**ADDENDUM NO. 3**

FOR: WEBB COUNTY YOUTH VILLAGE REHABILITATION CENTER  
FOR WEBB COUNTY  
111 CAMINO NUEVO ROAD, HWY 359  
LAREDO, TEXAS 78041

ADDENDUM DATE: July 6, 2016

ARCHITECTS PROJ. NO.: 1401

# 1R - WINDOW ELEVATIONS

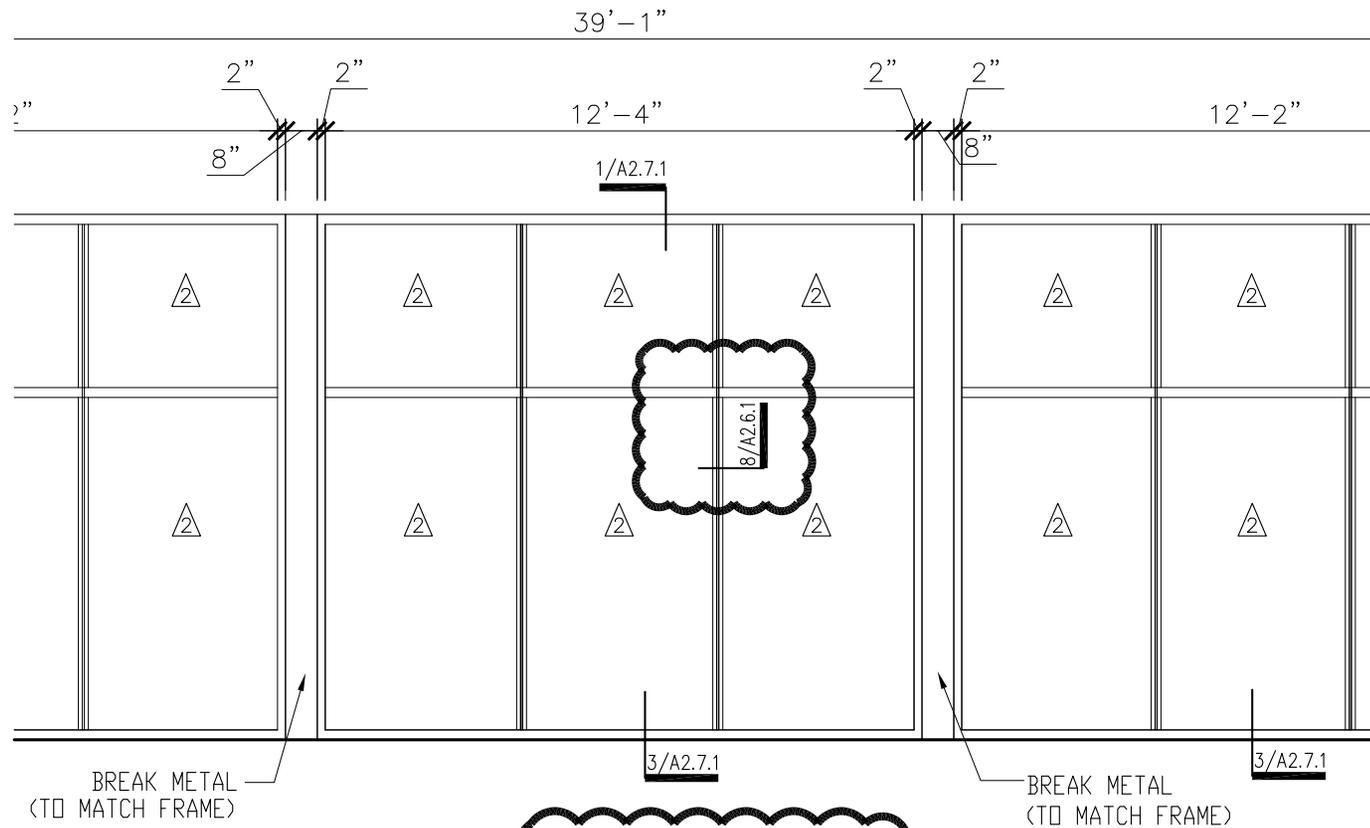
<ol style="list-style-type: none"><li>4. Add elevation tag 12/A5.6 at TV Room 202; see attached 1R/A2.2.</li><li>5. Add elevation tag 10/A5.6 Typical at all Dorm Rooms; see attached 1R/A2.2.</li><li>6. Add note, "Standing Seam Metal at all Canopies".</li></ol>
D3-5	A2.3	<ol style="list-style-type: none"><li>1. Revise Door Schedule as noted in attached drawing.</li><li>2. Revise Interior Finish Schedule; as noted in attached drawing.</li><li>3. Revise Glazing Legend as noted in attached drawing.</li><li>4. Add note, "Contractor to verify size of Type A door, refer to Door Schedule".</li></ol>
D3-6	A2.4	<ol style="list-style-type: none"><li>1. Revise WA-3 window elevation; see attached WA-3</li><li>2. Add section tag 8/A2.6.1 at window WA-12 butt joint.</li><li>3. Revise Glazing Legend as noted in attached drawing.</li></ol>
D3-7	A2.5	<ol style="list-style-type: none"><li>1. Revise WA-18 window elevation; see attached WA-18</li><li>2. Revise WA-19 window elevation; see attached WA-19</li><li>3. Revise WA-20 window elevation; see attached WA-20</li><li>4. Add window type WA-30 &amp; WA-31; see attached 1R/A2.5</li><li>5. Revise Glazing Legend as noted in attached drawing</li></ol>

# 4R - SECTION DETAIL

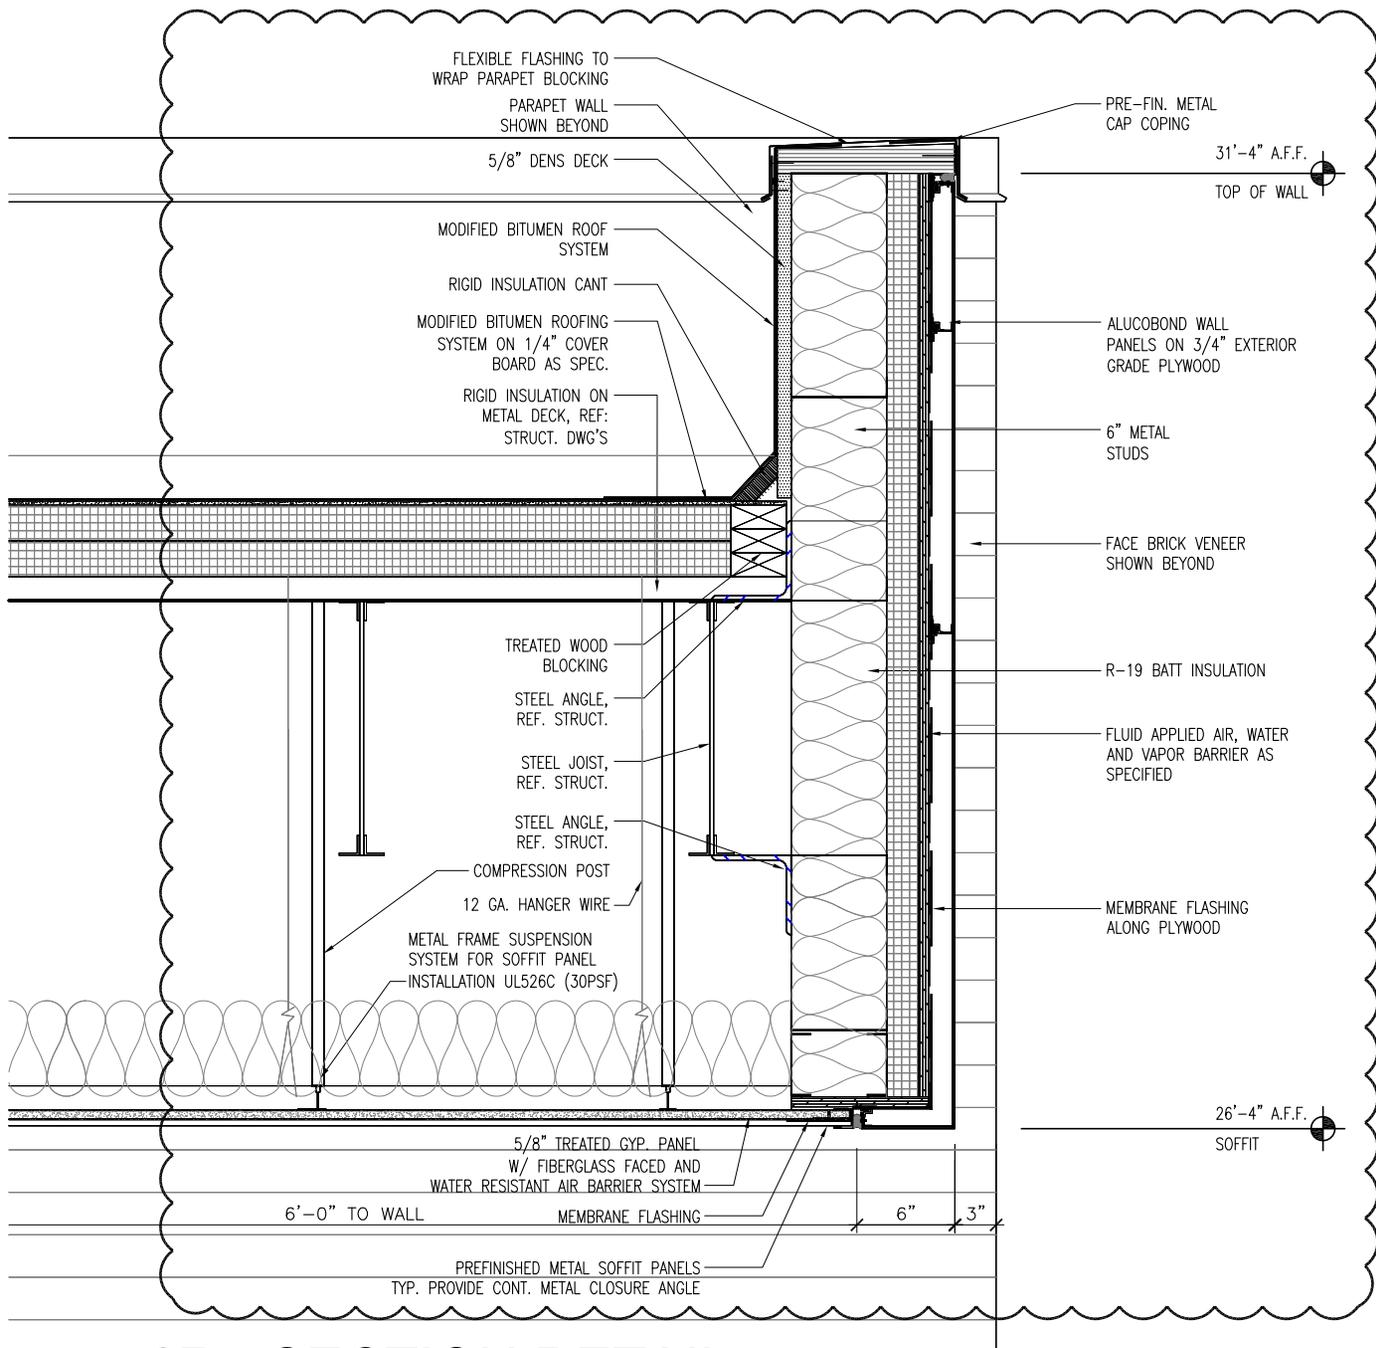
D3-19	A4.8	<ol style="list-style-type: none"><li>1. Revise Detail 4; see attached 4R/A4.8</li><li>2. Revise Detail 6; see attached 6R/A4.8</li><li>3. Revise Detail No.1, lower left to read, "Detail No. 2".</li></ol>
D3-20	A5.3	<ol style="list-style-type: none"><li>1. Revise dimension at Shower 209; see attached detail 1R/A5.3</li><li>2. Revise dimension at Men's Toilet 208; see attached Detail 1R/A5.3</li></ol>
D3-21	A5.8	<ol style="list-style-type: none"><li>1. Add Detail No.4; see attached Detail 4/A5.8</li><li>2. Add detail section tag 4/A5.8 to top of steps, floor to tread intersection</li><li>3. Add detail section tag 2/A5.8 at Detail No.1</li><li>4. Revise detail callout tag 5/A4.8 at to read 3/A4.8 at Detail No. 2</li></ol>
D3-22	A7.1	<ol style="list-style-type: none"><li>1. At note to read, "Provide 5/8" gypsum board under stairs.</li><li>2. Revise all light fixture tags to match E1.1 &amp; E1.2 (refer to MEP Sheets ES1.1, E1.1 &amp; E1.2.)</li></ol>

**1** **1** FOUNDATION PLAN- RECREATIONAL BASKETBALL COURT  
SCALE: 1/8" = 1'-0"

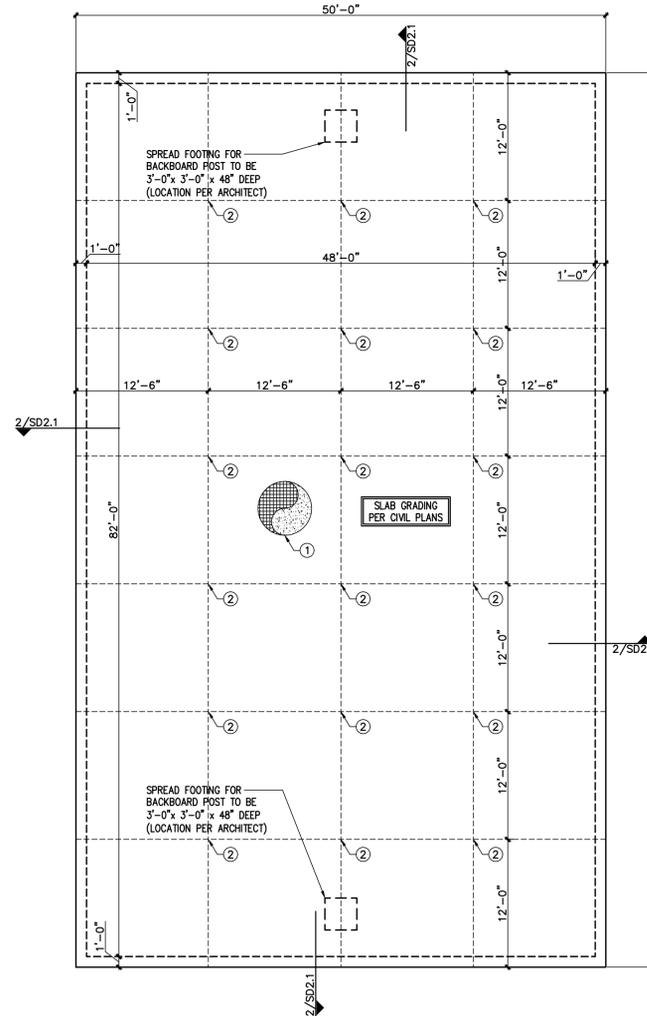
<b>Item</b>	<b>Reference Drawing(s)</b>	<b>Description</b>
D3-1	S-2.1	1. Add drawing Foundation Plan Basketball Court, refer to attached sheet S-2.1
